- a. Alteration/Addition
 - **i.** Billy Wood Appliance, DRB-001911-2022 Proposed changes to the building façade, color, and landscape.

FACADE DESIGN FOR: BILLY WOOD APPLIANCE

DESIGN TEAM/DRB COMMENT SHEET The comments below are staff recommendations to the Design Review Board (DRB) and do NOT constitute DRB approval or denial.				
PROJECT NAME: Billy Wood Appliance DRB#: DRB-001911-2022 DATE: 07/27/2022 08/15/2022 (Staff recommendation is unchanged from 07/27) RECOMMENDATION: Approval Approval with Conditions Denial RECOMMENDED CONDITIONS: Denial Denial				
APPLICATION MATERIAL				
DRB REQUIREMENTS	Complies Yes	No	Not Applicable	Comments or Conditions
Detail Illustrating Connection to Existing Structure				Based on the illustrations and the drawings it appears the caves of the existing dormer will extend beyond the left and right of the main entry portico. It would be helpful to have an indication of the existing roof overhang on the drawings.

AO SITE PRINT DATE 8/8/2022 9:18:28 PM

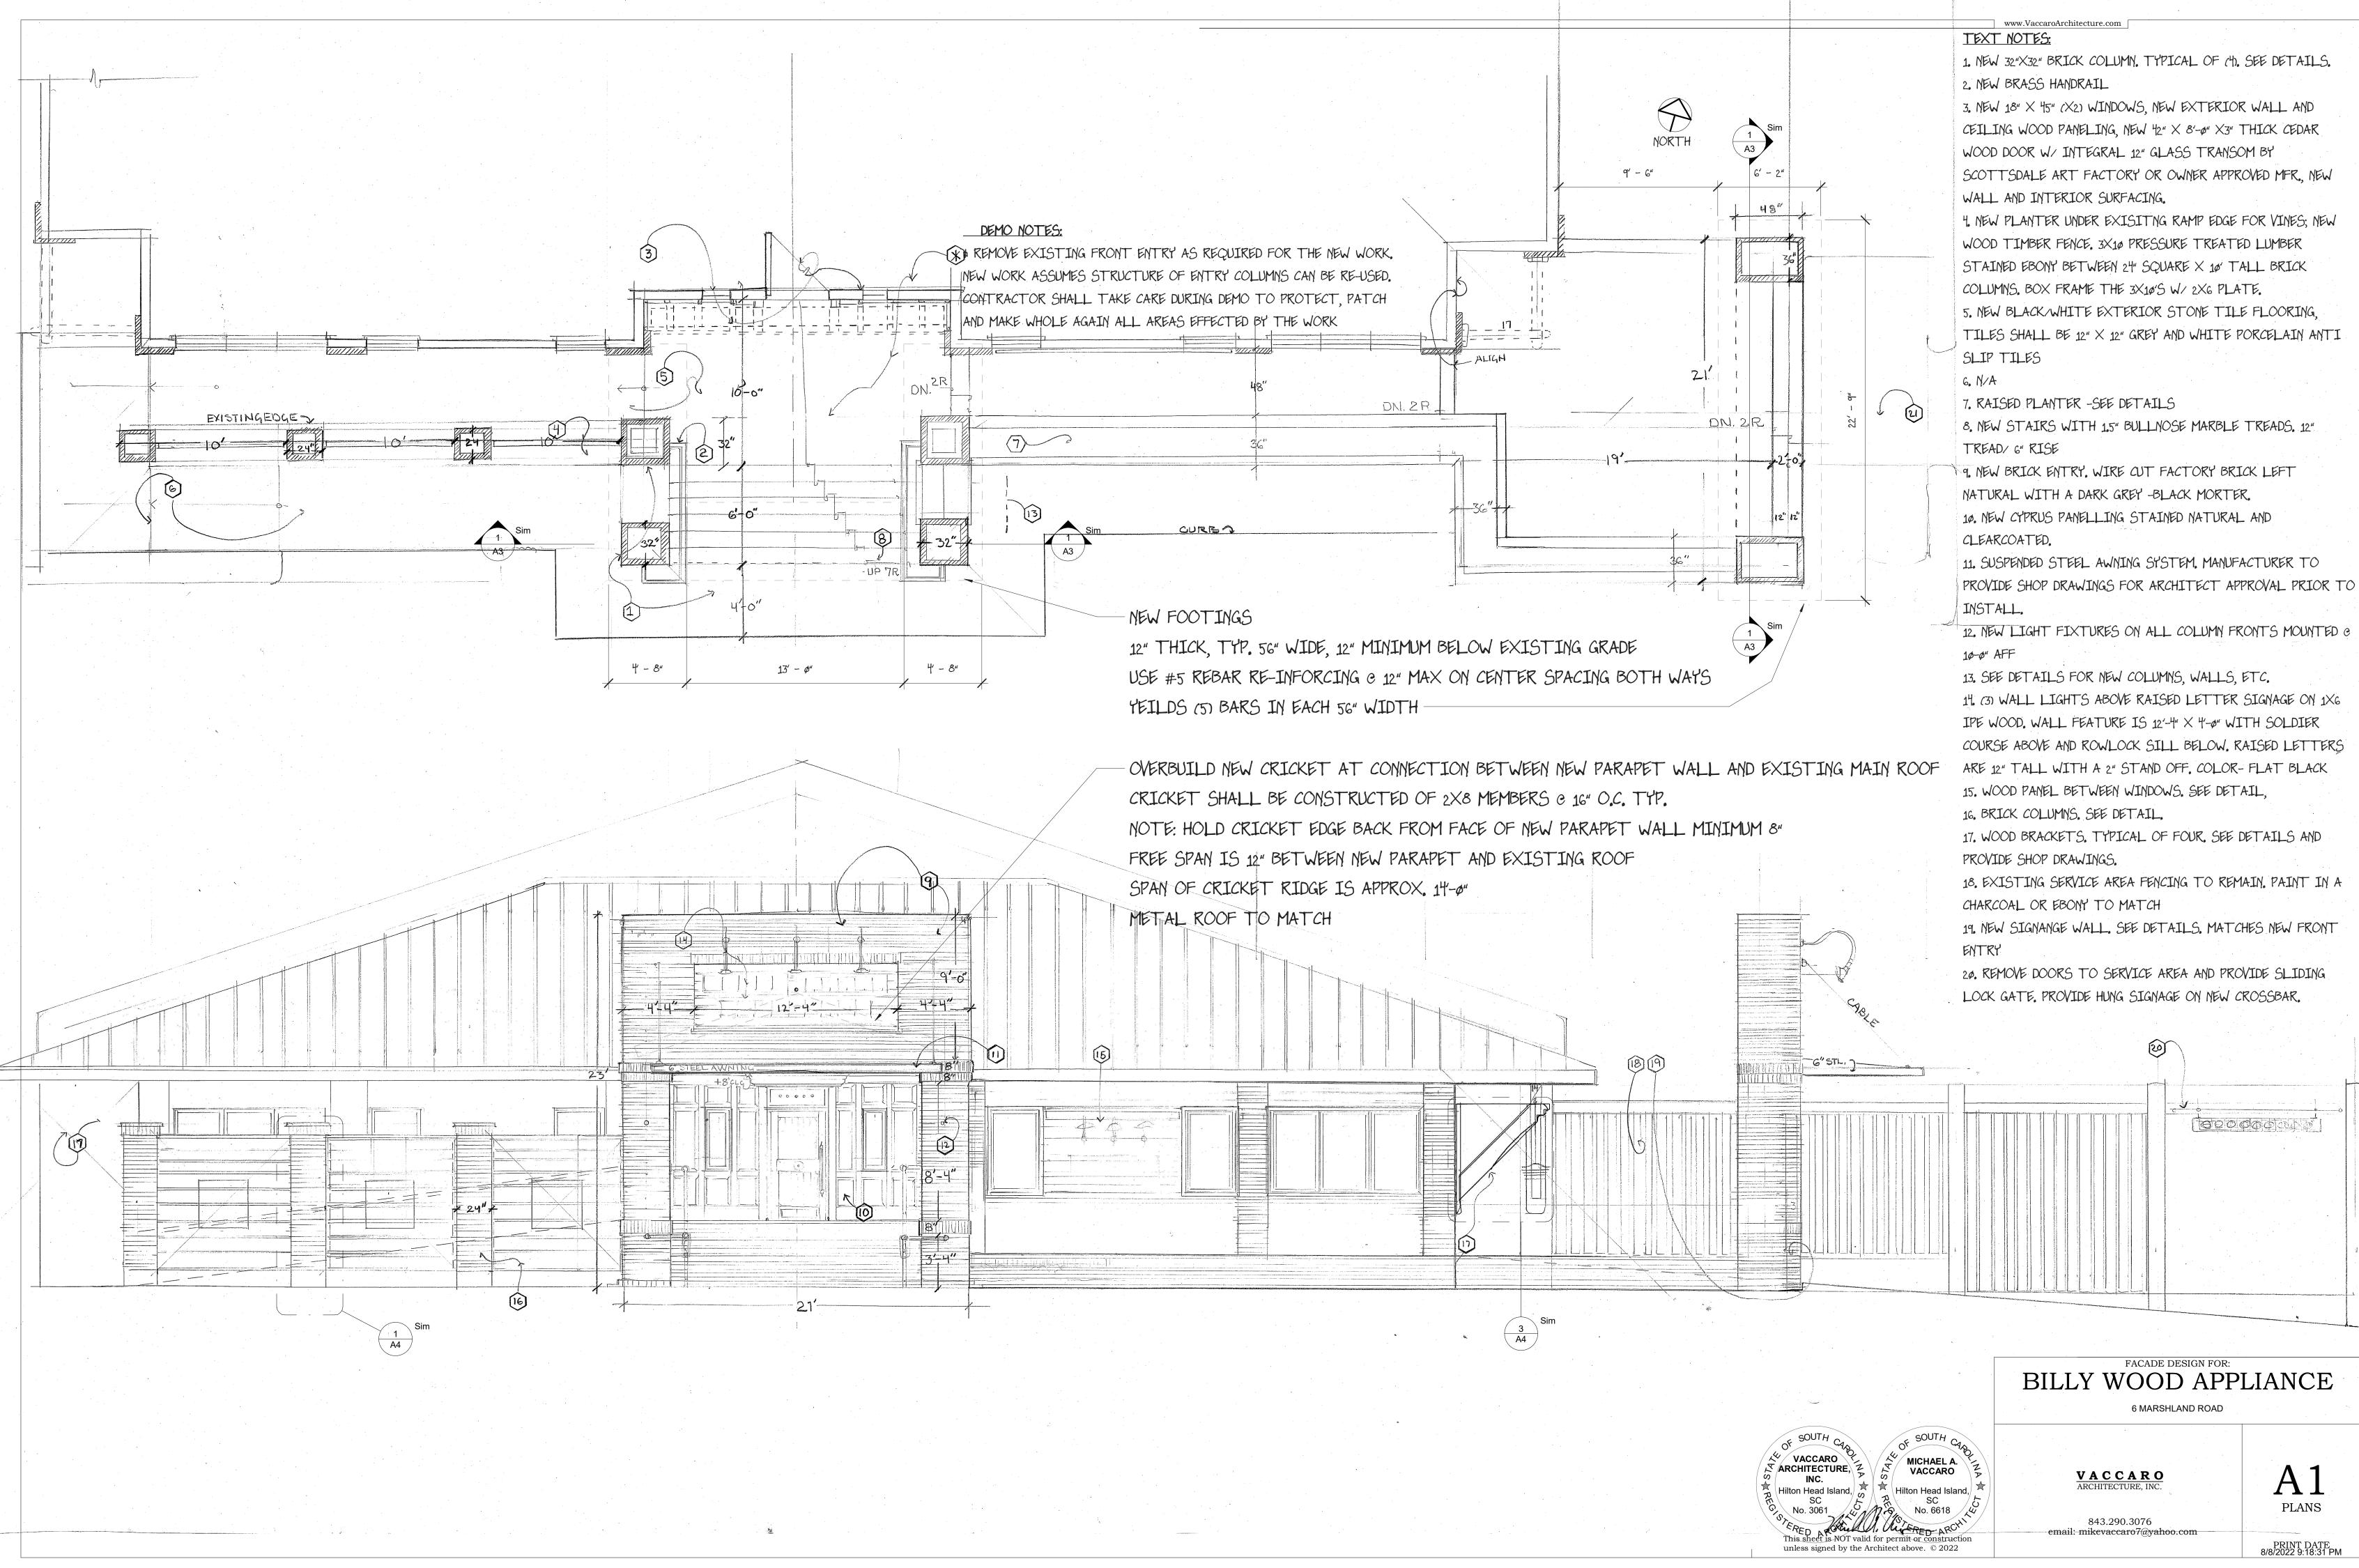
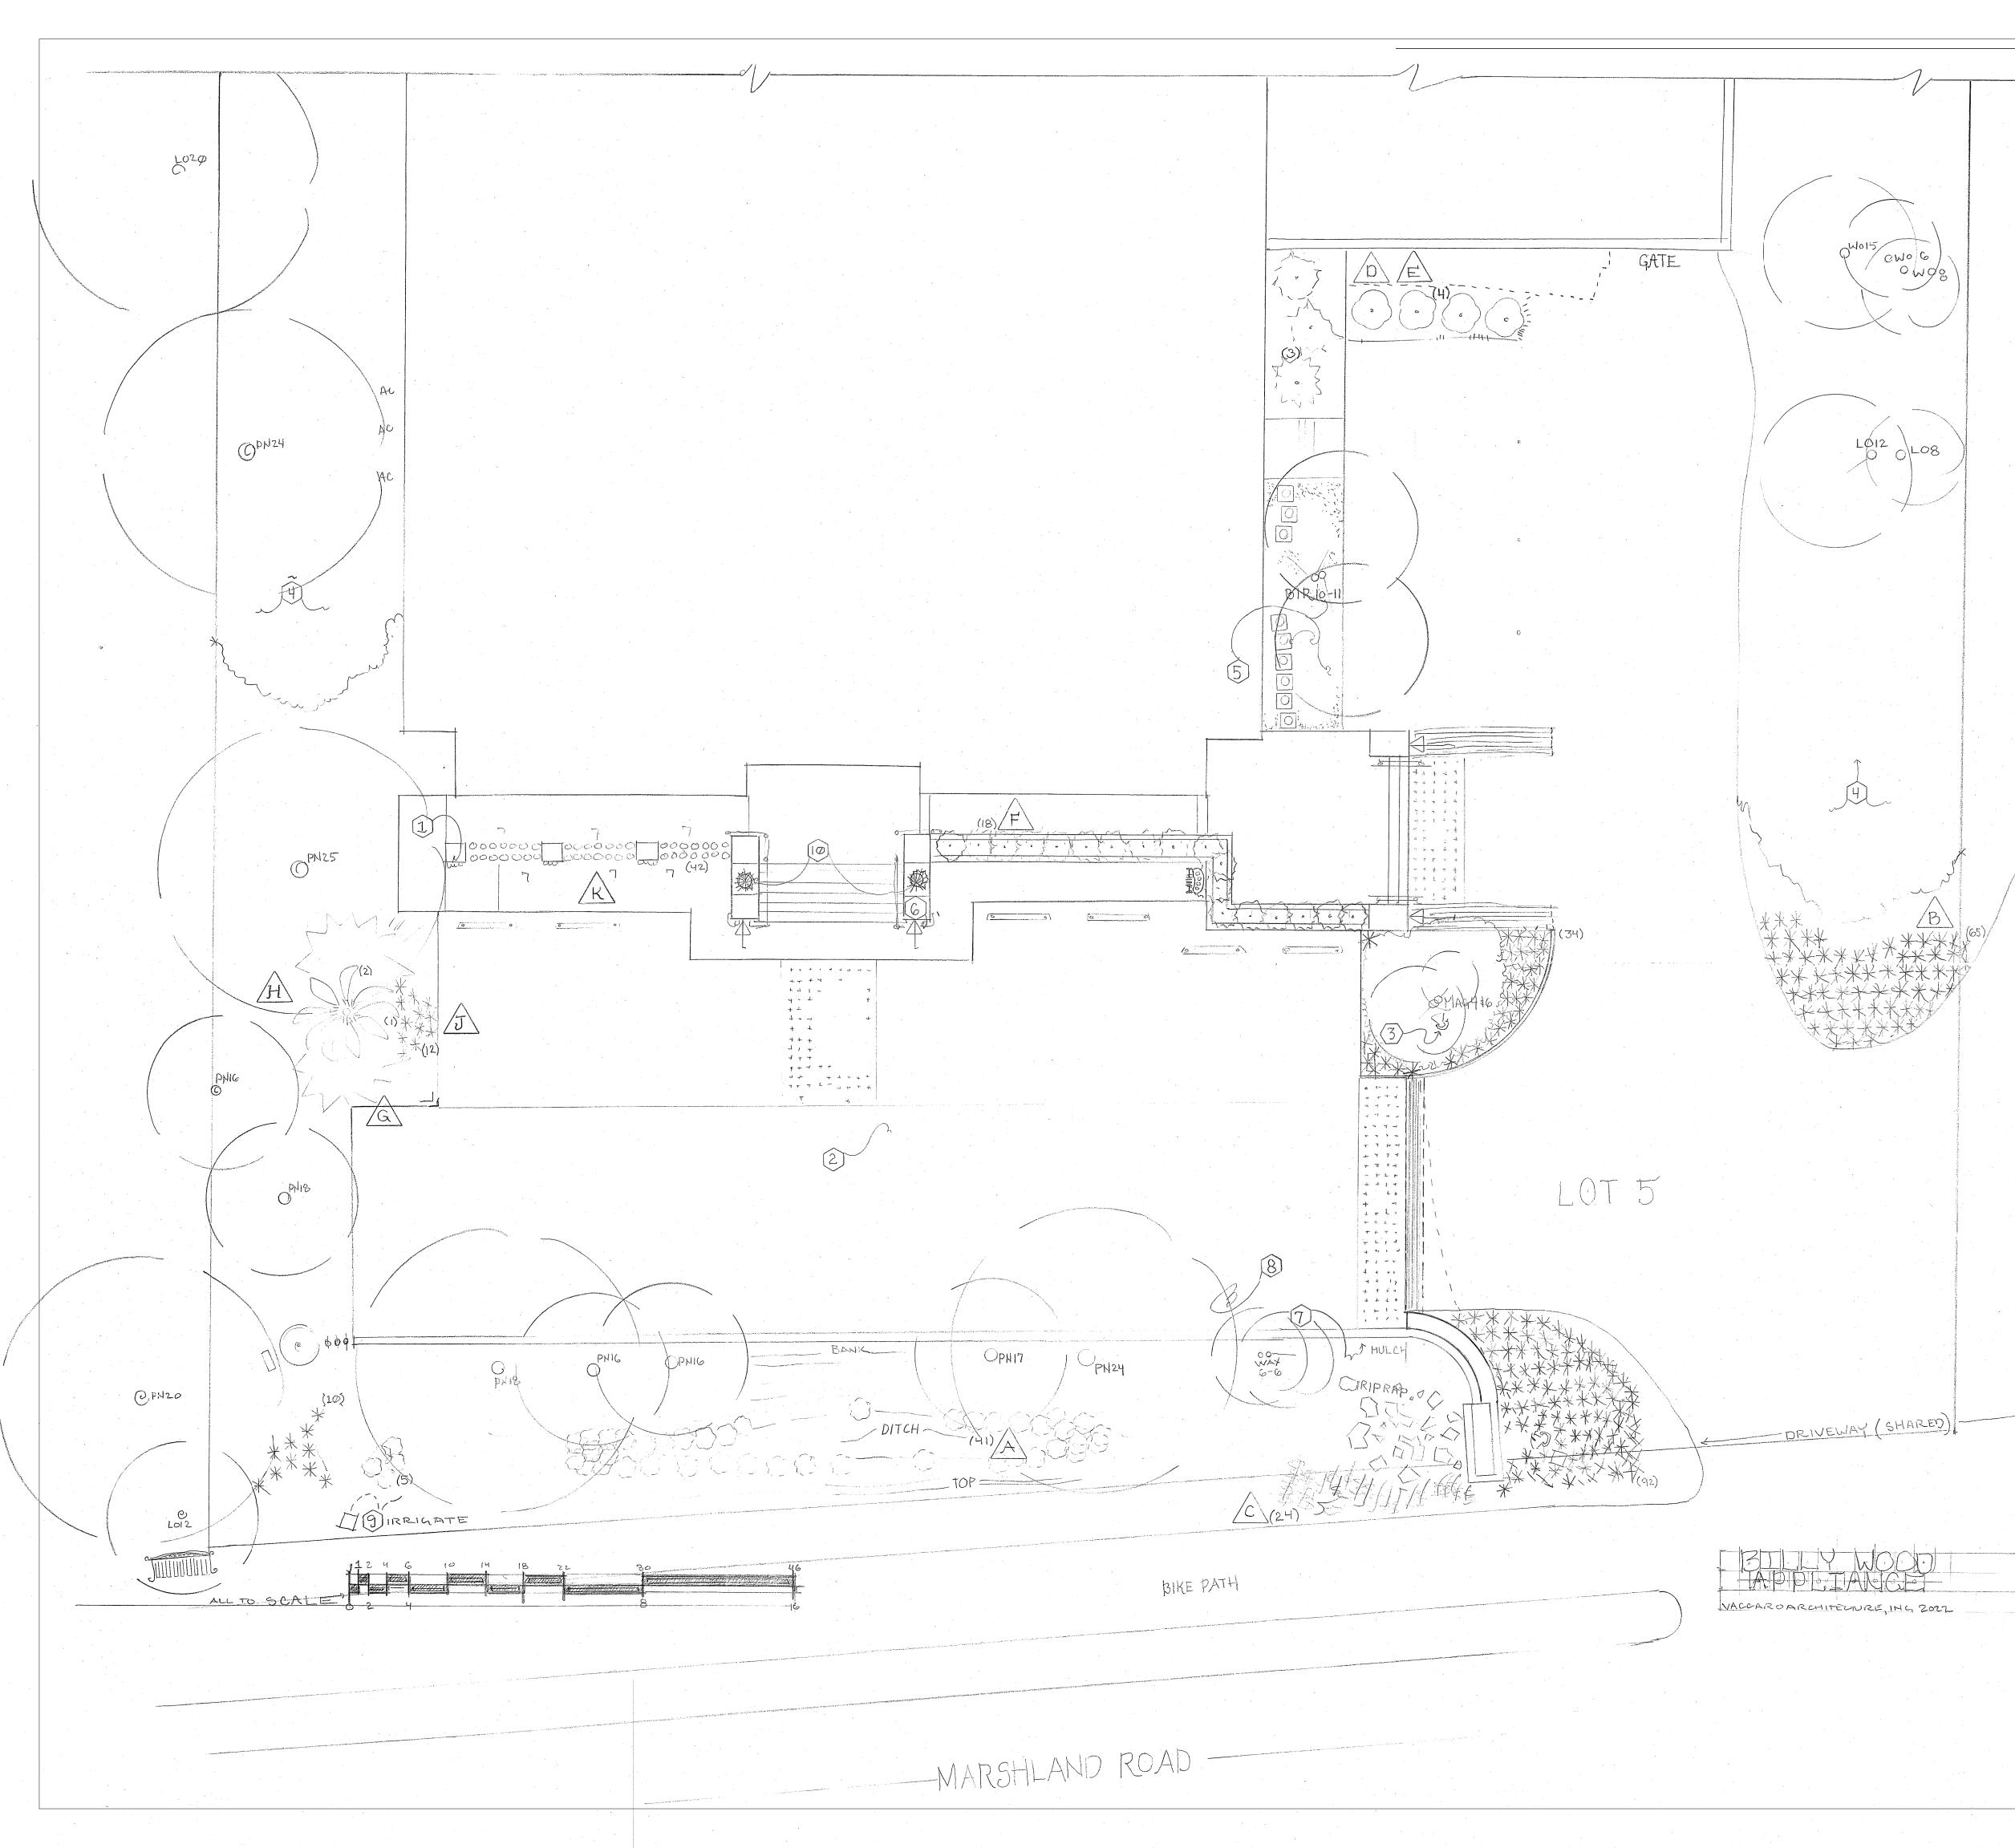
ARCHITECTURAL DESIGN				
DESIGN GUIDE/LMO CRITERIA	Complies Yes	No	Not Applicable	Comments or Conditions
Promotes pedestrian scale and circulation				Consider adding a dedicated pedestrian access to the pathway along Marshland Road.
Utilizes natural materials and colors				 Use a bronze or gunmetal finish on the handrails and sconces instead of brass per Design Guide, Page 15. The proposed color is not an earth tone in keeping with the Design Guide, pace 16. The proposed stucco color will wash out in the sun to white and is too great a contrast with

MISC COMMENTS/QUESTIONS			
1.	This project requires a Minor Development Plan Review application for the site work. Please contact Nicole Dixon at nicoled@hiltonheadislandsc.gov or at 843-341-4686 with any questions about this process.		
2.	This project requires a Building Permit. Please contact Tony Pierce at tonyp@hiltonheadislandsc.gov or at 843-341-4675 with any questions about this permit.		
3.	Provide a project narrative per the application form.		
4.	Provide photos of the existing structure per the application form.		
5.	Show wheel stops on all spaces including compact in the front.		
6.	Provide a physical color board per the application form.
